Re: **Herring Road Macquarie Park Urban Activation Precinct Submission to public exhibition**

Herring Road
Urban Activation Precinct

Submission on behalf of AMP Capital

FIGURE 2 – PRELIMINARY MASTERPLAN TOWER LOCATIONS AND REQUESTED HEIGHT CONTROL BOUNDARY

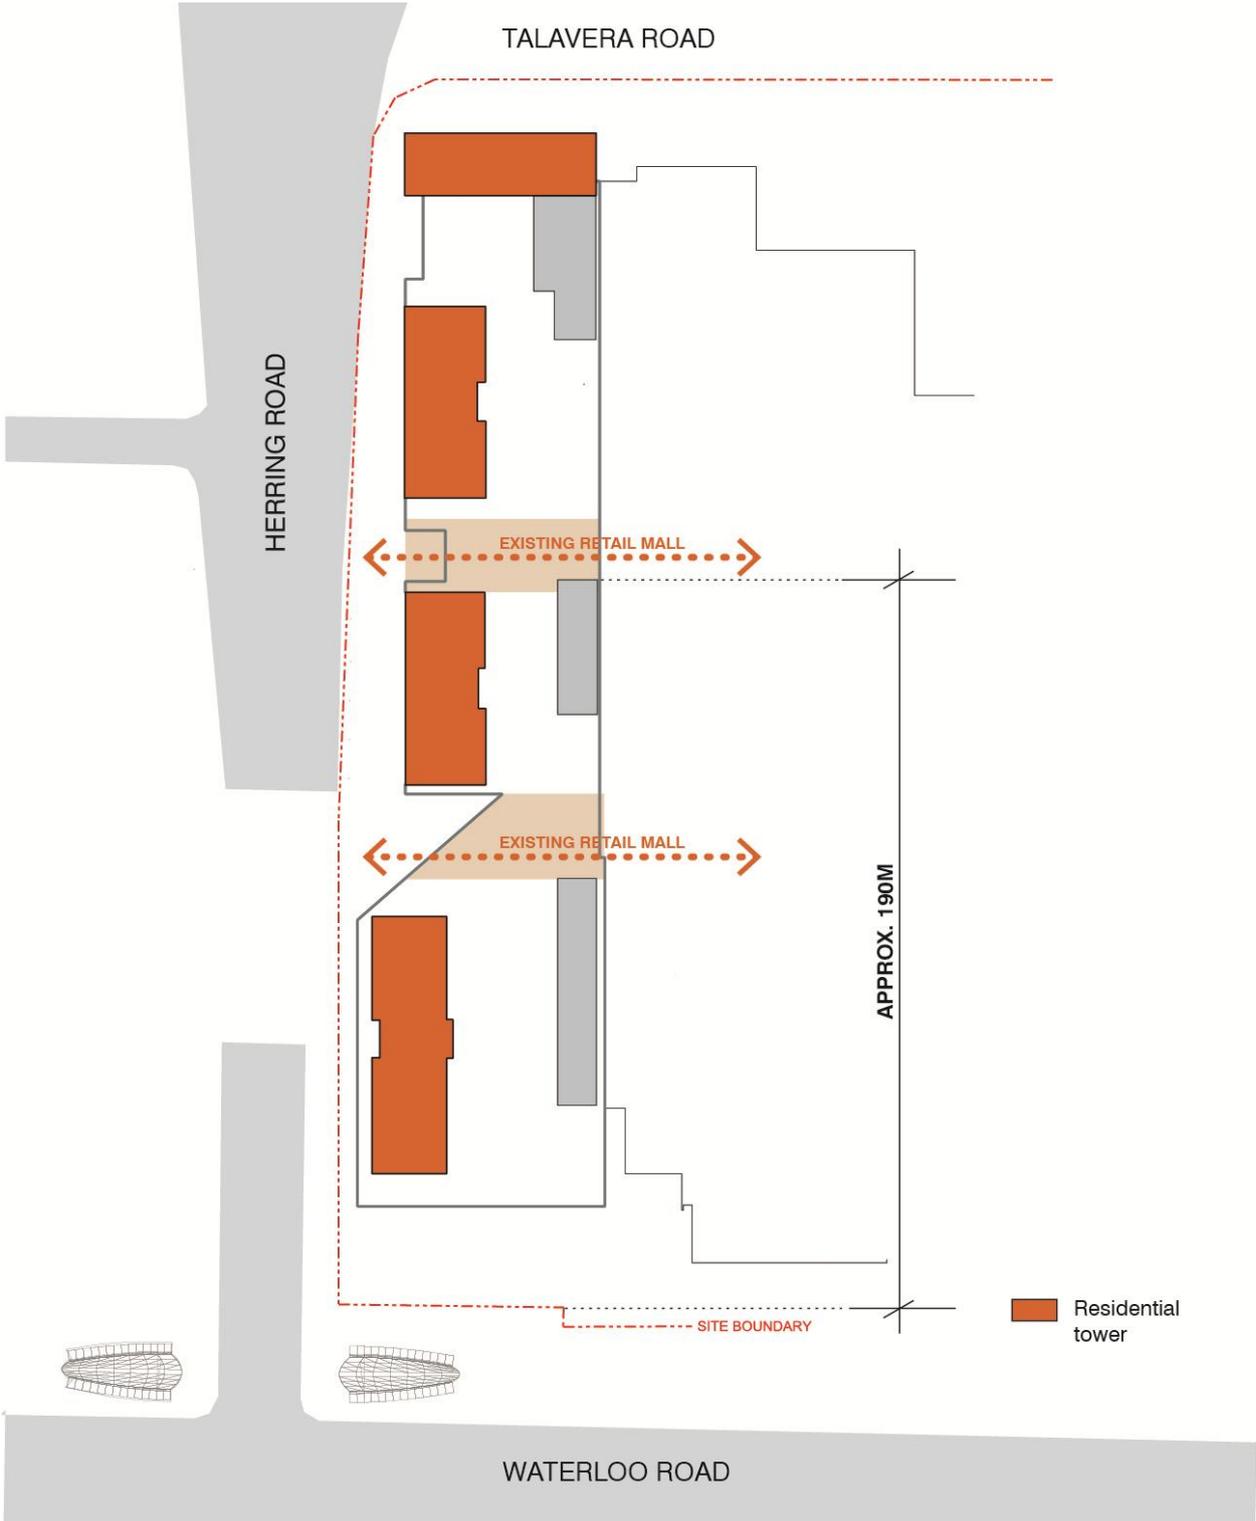
Accordingly, AJC have prepared an extract of the preliminary Masterplan for the Macquarie Centre site which indicates that for two tower forms to be wholly located within the 120 metre height control zone, the boundary of the 120 metre height control would need to move 30 metres north along Herring Road. This is illustrated in **Figure 2**.

Accordingly, it is requested that the 120 metre height control be extended approximately 30 metres north along Herring Road to accommodate the two tower forms fronting Herring Road to be located within a single height control. This will also enable the Macquarie Centre site to deliver development which more closely aligns to the proposed FSR, and therefore work to achieve the overall objective of the Herring Road UAP.

AMPC support the proposed height controls across the Macquarie Shopping Centre site, however request the 90m and 120m height control zone boundary be shifted approximately 30 metres north along Herring Road. This would enable two towers to be located within each height control zone as envisaged by the UAP illustrative masterplan.

FIGURE 3 – RECOMMENDED EXTENT OF ACTIVE FRONTAGES ALONG MACQUARIE CENTRE FRONTAGES

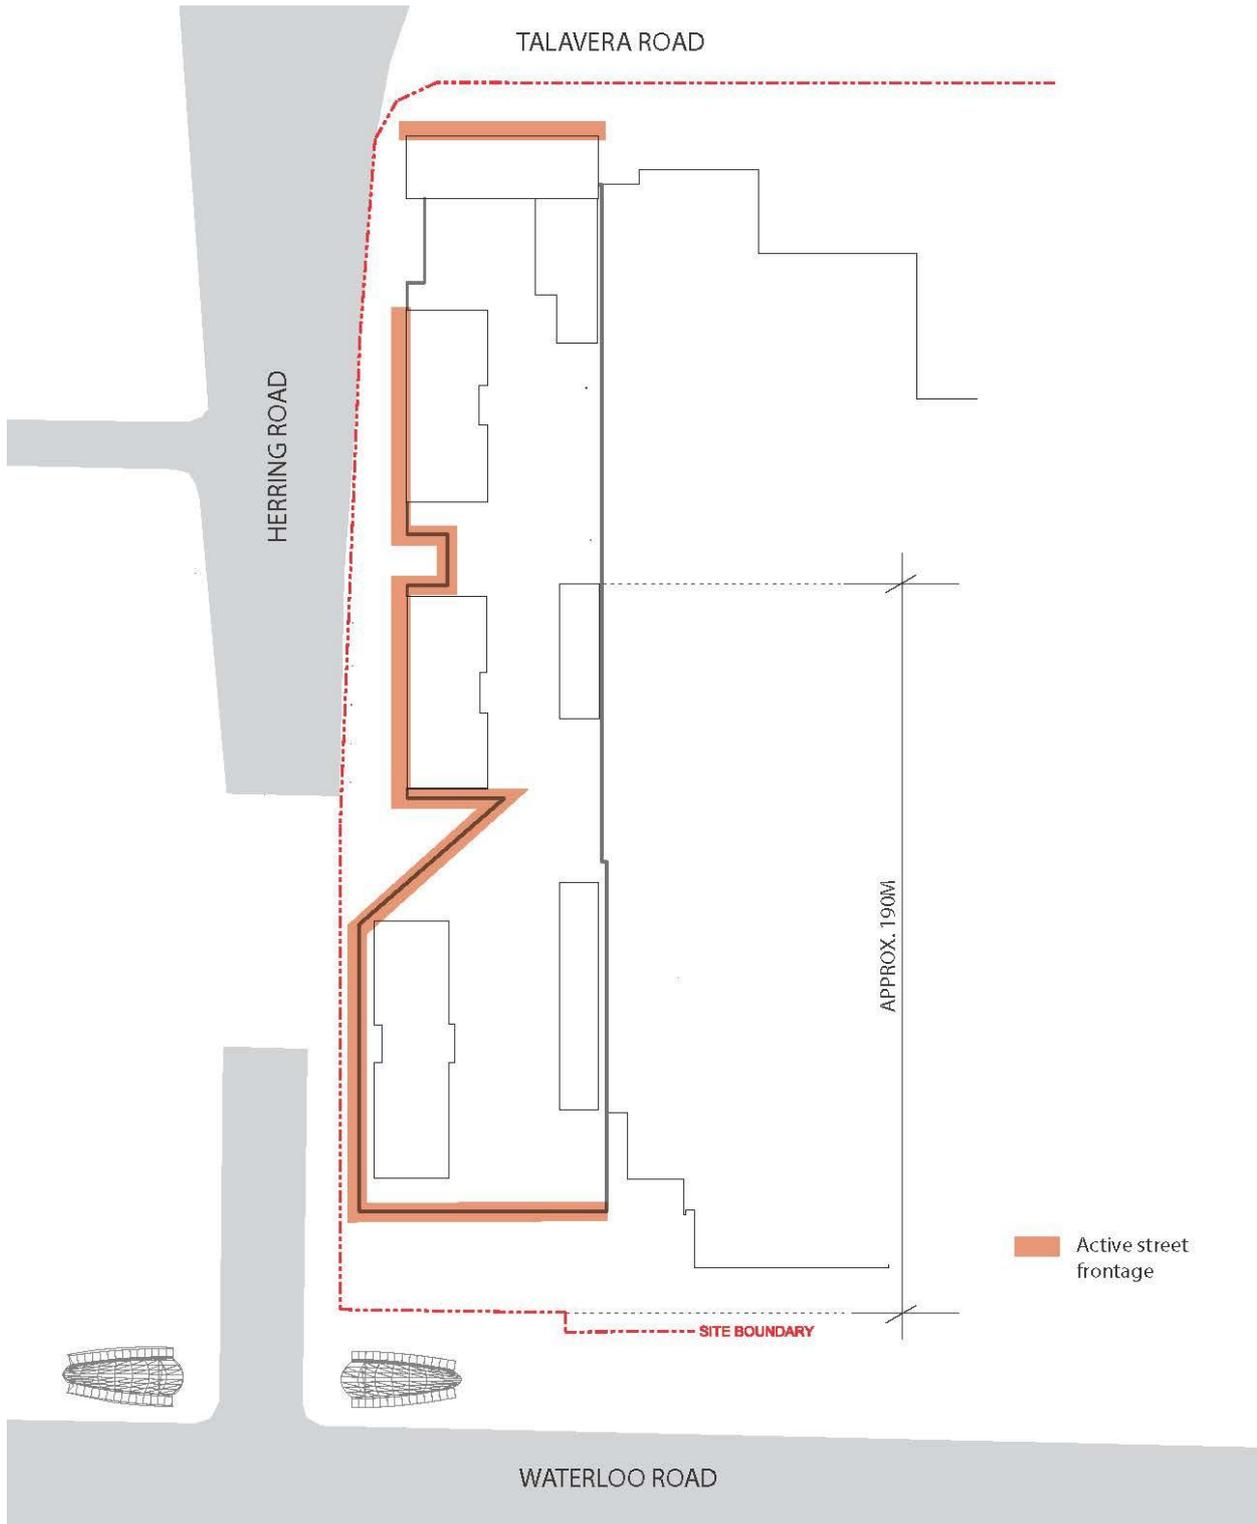
The exhibited documentation indicates that the zero setbacks proposed along the Herring Road and Waterloo Road frontages to the Macquarie Centre site are proposed to 'help activate the street edge'. However it should be noted that the topographical change along Waterloo Road which is acknowledged in Figure 24 of the exhibited documentation limits opportunity for this full extent of the Waterloo Road frontage to deliver an activated street edge. Further the topography along this street presents a barrier for pedestrian movements along this site boundary, and therefore lends itself to use as entries into loading areas to service the Centre.

Accordingly, AMPC request that the Department clarify that the recommended changes to the Ryde DCP 2011 relating to activated frontages along Waterloo Road do not require the full extent of the frontage to be activated. Rather AMPC request a direction be incorporated which acknowledges that activation of the Waterloo Road frontage will only be required adjacent to the forecourt surrounding the Macquarie University Train Station, referred to as 'Station Plaza' in the current Ryde DCP 2011. The success of this part of the Waterloo Road frontage of the Macquarie Centre to support active frontages will be based on the volume of pedestrian movements to and from the train station, and its location at the top of the Herring Road ridgeline.

Due to the topography of the site, active frontages are not achievable along the full extent of the Waterloo Road frontage of Macquarie Shopping Centre. Active frontages along Waterloo Road should be limited to the edge of Station Plaza.
